Access Compliance Report

Public Rights-of-Way

(Curb Ramps)

Intersection ID: 43757	Main Street: DERVISH_LN	Cross Street: ZIEGLER_LN	Location:	W
ADA ID: 59B217C819BA	Ramp Type: PerpDiag	Initial Pass/Fail: Fail	Overall Compliance: No	Severity Score: 17.5
Codes/Mitigation Info/Possible Solution		Field Measurements/Component Compliance

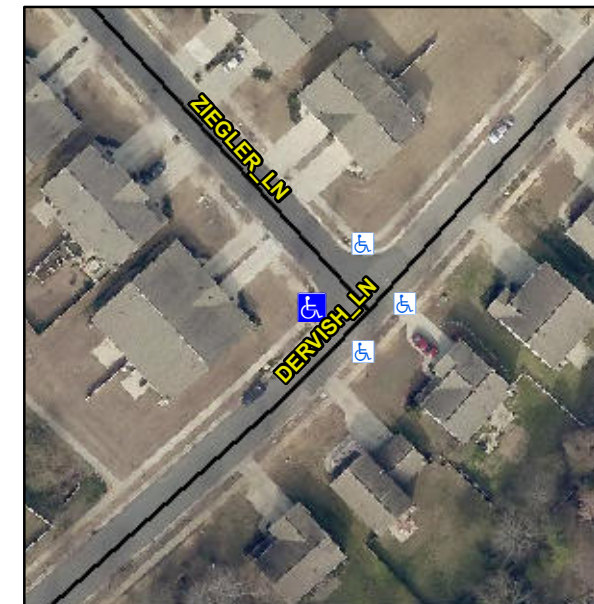
Not Found, R304.5.1

Compliance	Description	Data	Compliance	Description	Data
N/A	Ramp Length (in)	49.0	Yes	Ramp Slope (%)	6.4
No	Ramp Width (in)	35.0	Yes	Ramp XSlope (%)	1.6
N/A	Flare Type LT	N/A	N/A	Flare Type RT	N/A
N/A	Flare Slope LT (%)	N/A	N/A	Flare Slope RT (%)	N/A
N/A	Flare Traversable LT?	N/A	N/A	Flare Traversable RT?	N/A
N/A	Landing Length (in)	N/A	N/A	DWS Provided?	N/A
N/A	Landing Width (in)	N/A	N/A	DWS Contrast?	N/A
N/A	Landing Slope (%)	N/A	N/A	DWS Length (in)	N/A
N/A	Landing X Slope (%)	N/A	N/A	DWS Full Width?	N/A
N/A	Landing Curb? (Y/N)	N/A	N/A	DWS Offset (in)	N/A
N/A	Shared Landing?	N/A			
N/A	Gutter Ponding?	N/A	N/A	Gutter Slope (%)	N/A
N/A	Gutter Lip Ht (in)	N/A	N/A	Gutter X Slope (%)	N/A
N/A	Painted X Walk1?	No	N/A	Painted X Walk2?	No
	X Walk 1 Direction	To SE		X Walk 2 Direction	To NE
N/A	X Walk 1 Width (in)	N/A	N/A	X Walk 2 Width (in)	N/A
	X Walk 1 Slope (%)	6.6		X Walk 2 Slope (%)	8.0
	X Walk 1 X Slope (%)	4.7		X Walk 2 X Slope (%)	2.9

Remove & Replace Curb Ramp With Two New Directional Ramps or Equivalent.
